UNITED STATES PATENT AND TRADEMARK OFFICE

APPLICATION NO.	FILING DATE	FIRST NAMED INVENTOR	ATTORNEY DOCKET NO.	CONFIRMATION NO.
10/510,423	04/21/2005	Jaume Prat Terradas	30607/40513	4333
4743 7590 08/10/2007 MARSHALL, GERSTEIN & BORUN LLP 233 S. WACKER DRIVE, SUITE 6300 SEARS TOWER CHICAGO, IL 60606			EXAMINER LUONG, VINH	
			ART UNIT 3682	PAPER NUMBER
			MAIL DATE 08/10/2007	DELIVERY MODE PAPER

Office Action Summary

ATTACHMENT 1

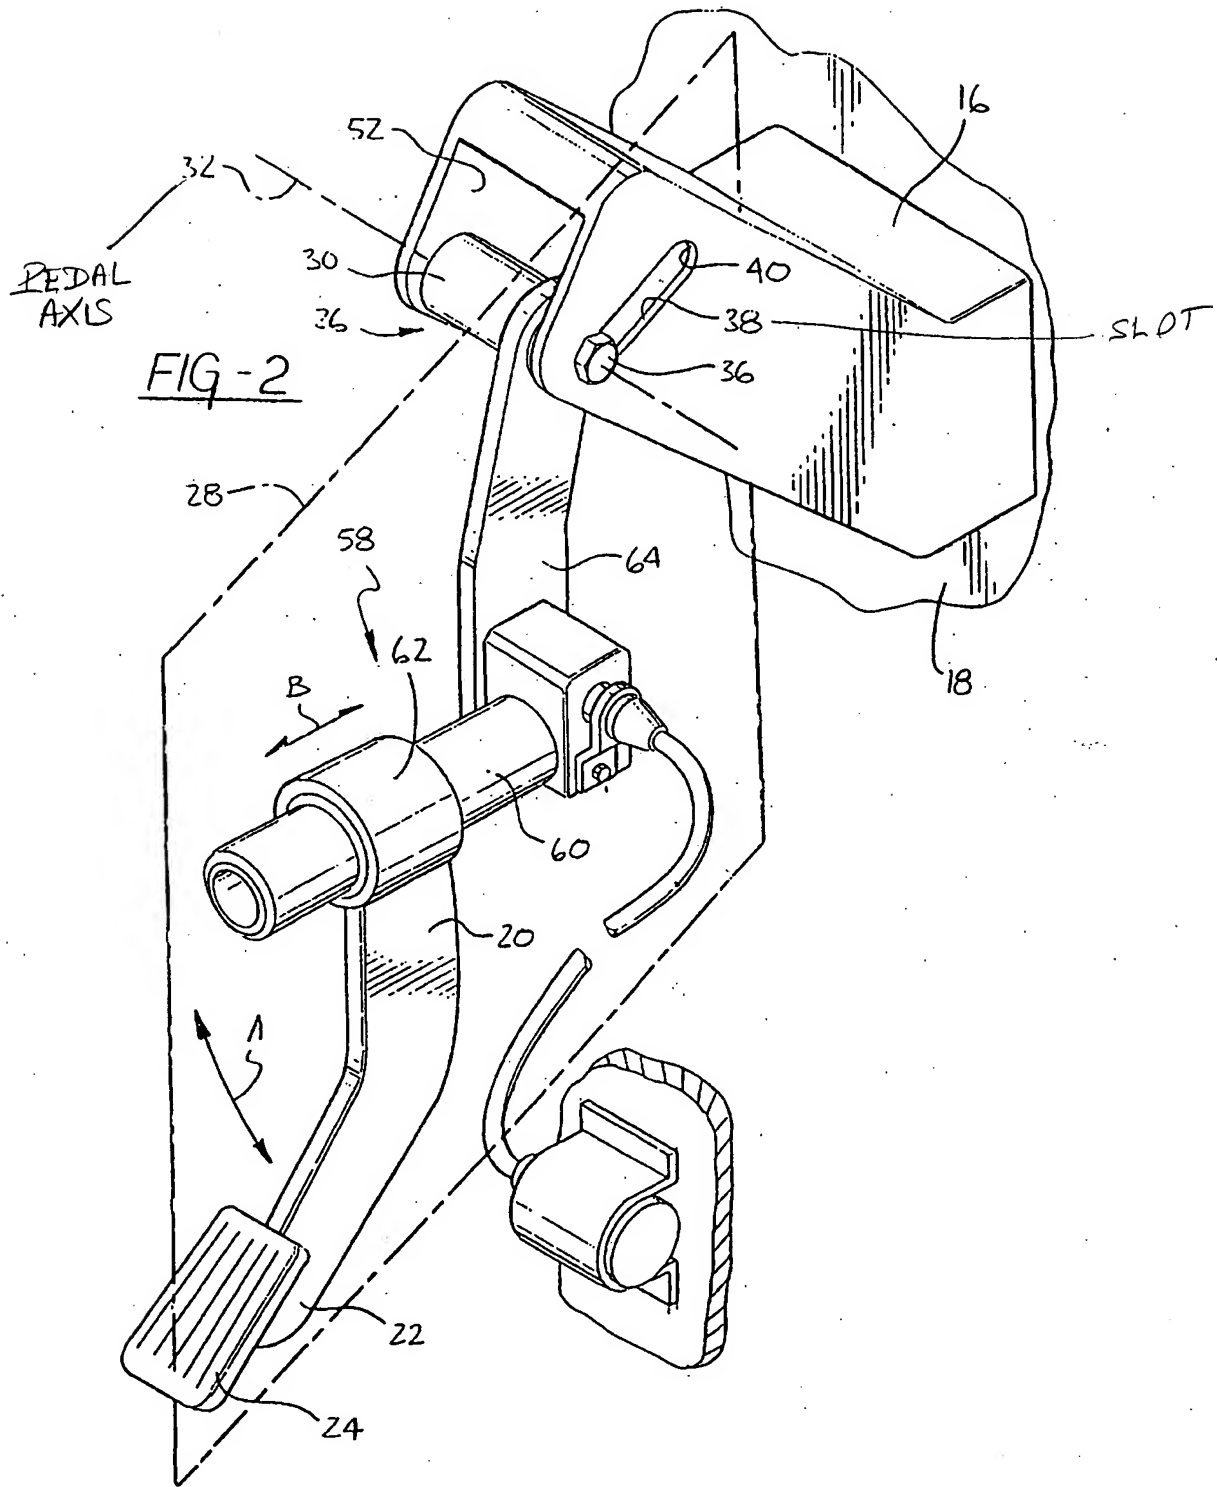
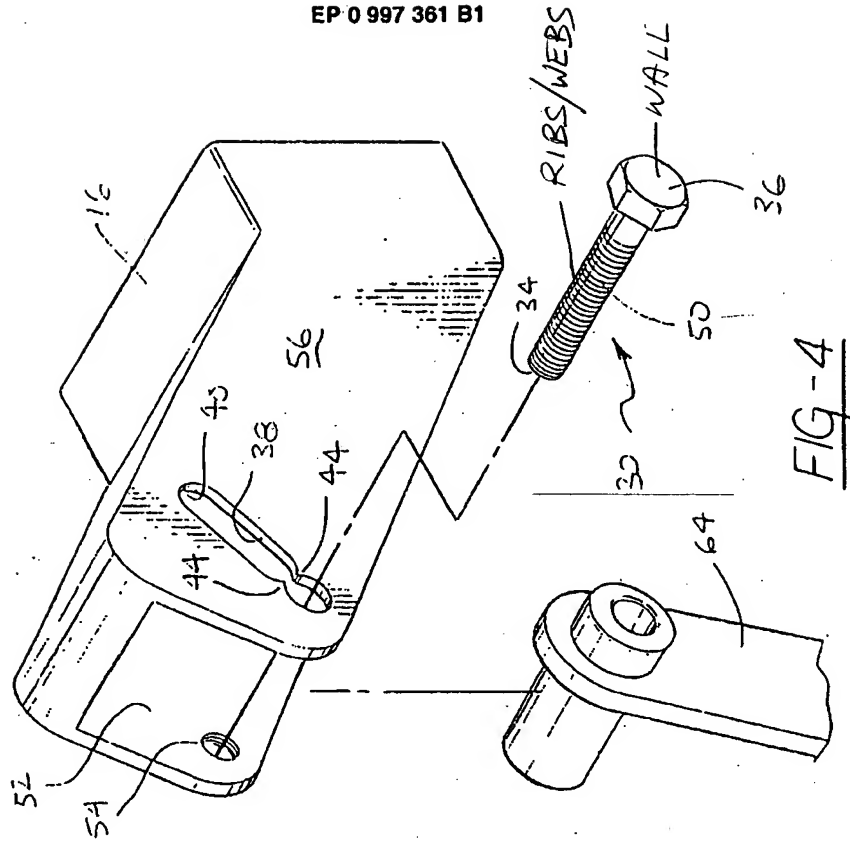
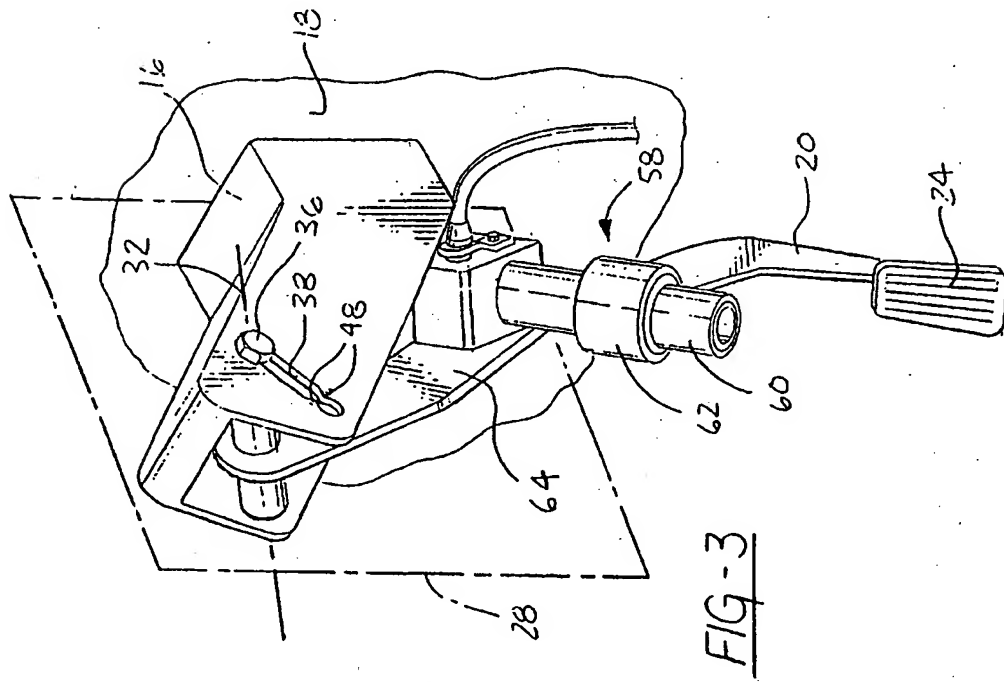
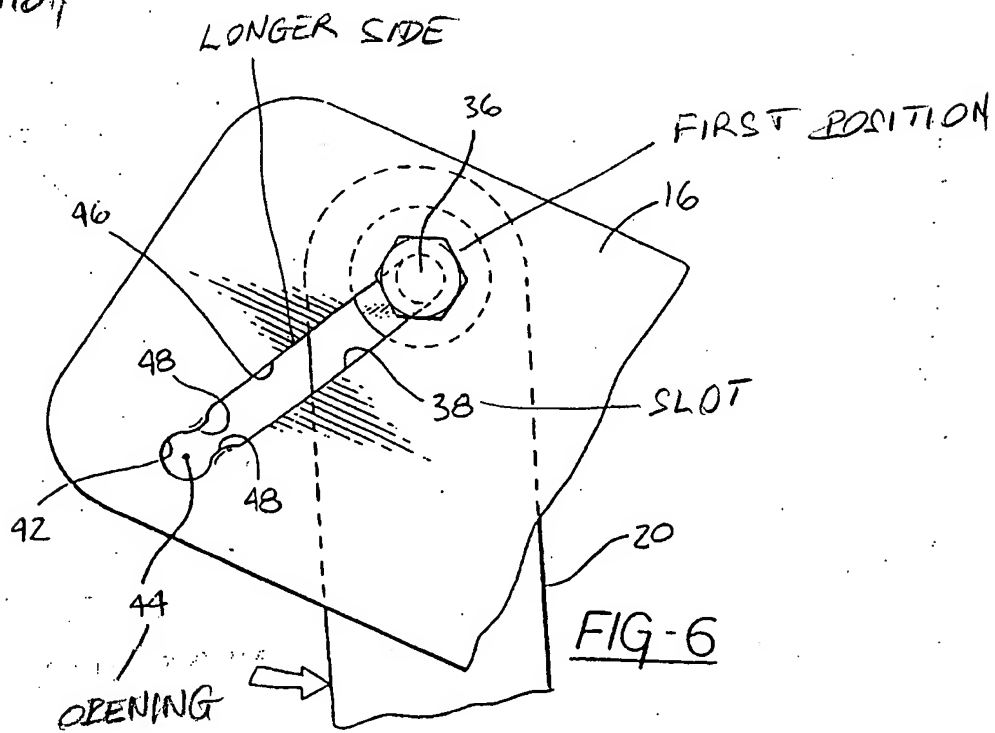
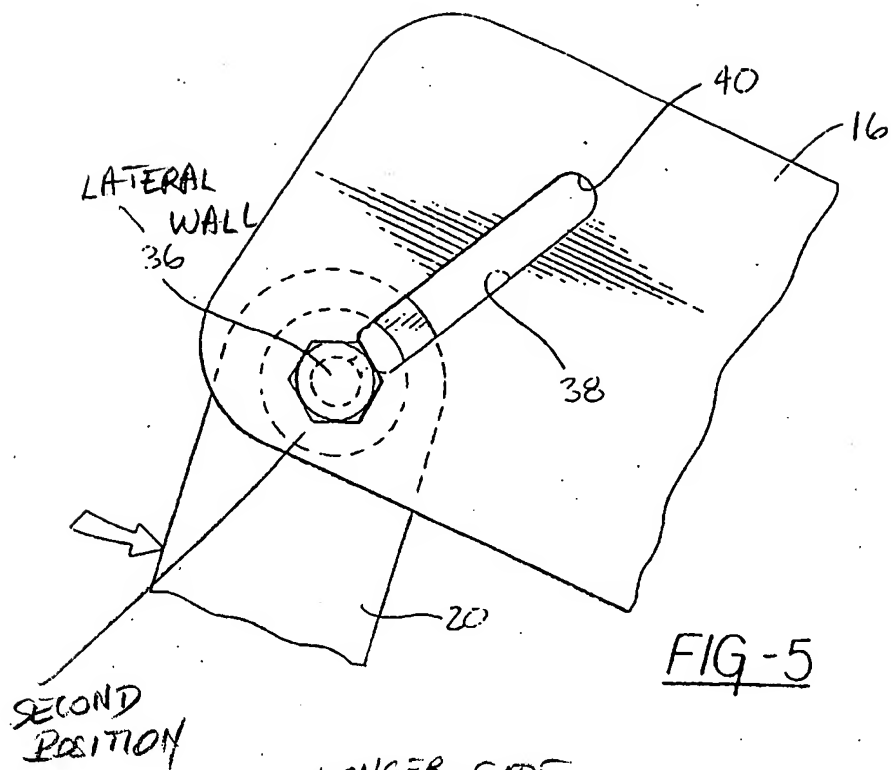
an opening 44 (see FIG. 6 in Attachment 1 hereinafter "Att. 1") for receiving and retaining the pedal axis 32, 30; and

the lateral walls 36 comprising ribs or webs 50 (FIG. 4 in Att. 1) that extend longitudinally in the slot 38,

the lateral walls 36 having a first position (FIG. 6) in which the lateral walls 36 project into the slot 38 and a second position (FIG. 5) in which the lateral walls 36 are moved out of the slot 38, wherein the pedal axis 32, 30 engages the lateral walls 36 and moves the lateral walls 36 from the first position (FIG. 6) to the second position (FIG. 5) by exceeding a mechanical limit loading of the pedal axis 32, 30 whereby the slot 38 receives the pedal axis 32, 30. *Ibid.* paragraph [0014] *et seq.* and Claims 1-19.

In the instant case, *Webster's II New Riverside University Dictionary*, 1994, defines “web” as “a structure of *threadlike* filaments spun by spiders or certain insect larvae” (emphasis added). Therefore, the threadlike filaments of the threads 50 of Ananthasivan's fastener/lateral walls 36 in FIG. 4 “read on” the claimed “webs.” As noted, the threads 50 of Ananthasivan's fastener 36 are equivalent to Applicant's threads/webs 52 in Applicant's FIG. 3A.

Fig. 2

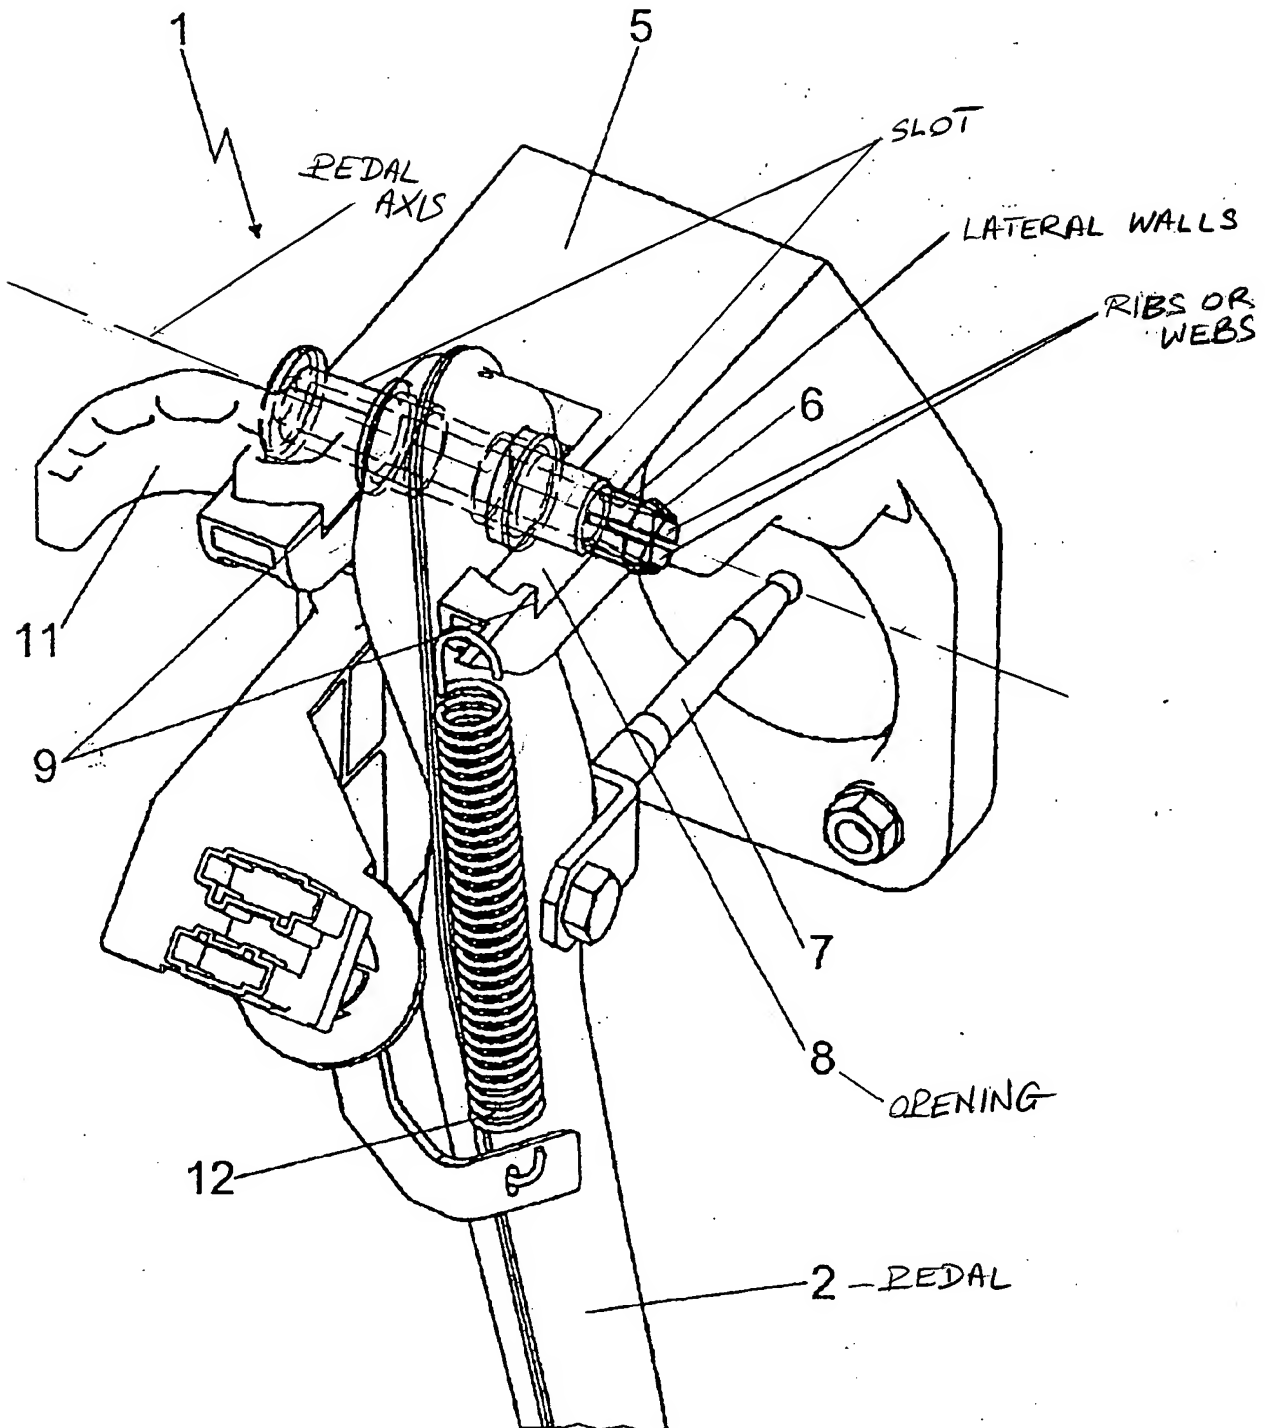
- a pedal 2 rotatably mounted by means of a pedal axis (see FIG. 2 of Attachment 2 hereinafter "Att. 2");

- a slot (unnumbered in FIGS. 2 and 5 in Att. 2) connected to the opening 8 and defining longer sides 6, the slot (Att. 2) comprising lateral walls 6 along the slot longer sides 6,

- the lateral walls 6 comprising ribs or webs (the ribs or webs are spaced from each other by gaps as seen in FIGS. 2 and 5),

- the lateral walls 6 capable of having a first position in which the lateral walls 6 project into the slot (FIG. 5) and a second position (FIG. 2) in which the lateral walls 6 are moved out of

Regarding claim 10, the slot (FIG. 2 of Att. 2) defines a predetermined displacement path of the pedal axis (Att. 2).

Fig. 5

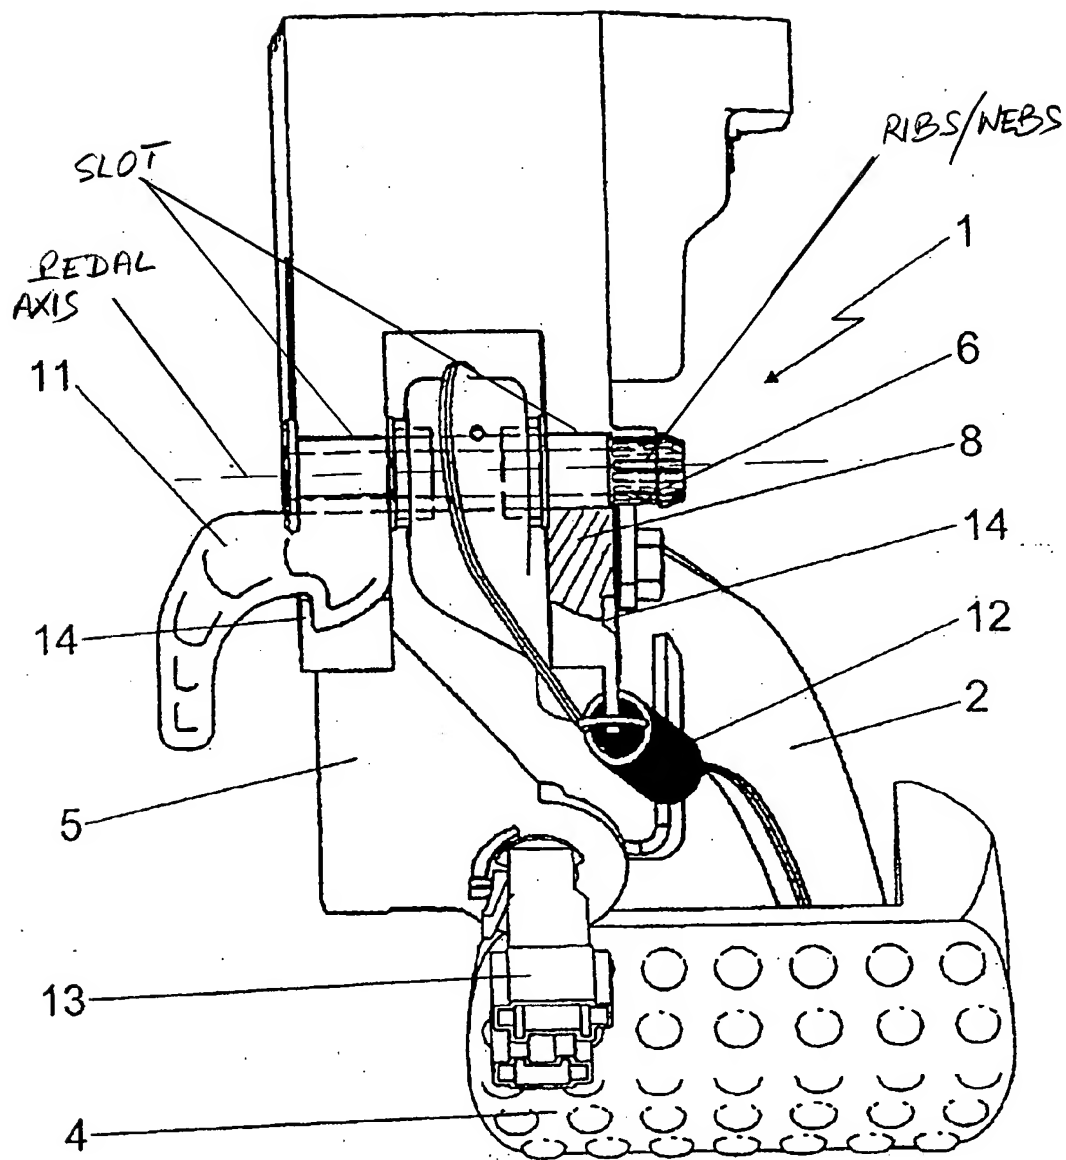
Regarding claim 11, the slot is formed by an elongated hole (FIG. 5 of Att. 2), which is partly closed by the lateral walls 6 projecting therein.

Regarding claim 12, the lateral walls 6 are capable of being bent, dismounted, or pushed away from the slot (FIG. 5 of Att. 2) in response to the mechanical limit loading by the pedal axis (Att. 2).
